Request	-	Maumee River Overlay Review for Façade Renovations
Location	-	2520 & 2534 N. Summit Street
Applicant + Owner	-	Kaiss Badwe 2344 108th Street Toledo, OH 43611
Architect	-	Duket Architects Planners 830 N. Summit Street Toledo, OH 43604
Attorney	-	Joanne Rubin 316 N. Michigan Street, Suite 725 Toledo, OH 43604

The staff recommends that the Toledo City Plan Commission recommend approval of MRO-2-24, a Maumee Riverfront Overlay Review for façade renovations at 2520 and 2534 N. Summit Street, to Toledo City Council for the following two (2) reasons:

MAUMEE RIVERFRONT OVERLAY REVIEW
TOLEDO CITY PLAN COMMISSION
REF: MRO-2-24
DATE: July 11, 2024
TIME: 2:00 P.M.

2 WEST ELEVATION
A1.0 SCALE 1/8" = 1'-0"

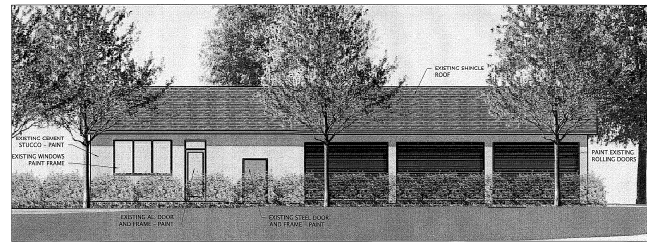
All proposed new buildings and renovations are subject to the commercial development standards under *TMC§1109.0200* and *TMC§1109.0500 – Façade Materials and Color*. The only changes proposed are the overhead doors to cover the existing open washing bays. **The proposed changes are acceptable as depicted.**

4. Building elevations are subject to TMC§1109.0400 – Building Façade Materials and Color. **Proposed elevations are acceptable as depicted.**
5. A detailed site, lighting, fencing and four (4) copies of a landscaping plan (separate from building & site plans) shall be submitted to the Plan Director for review and approval. Such plan shall include:
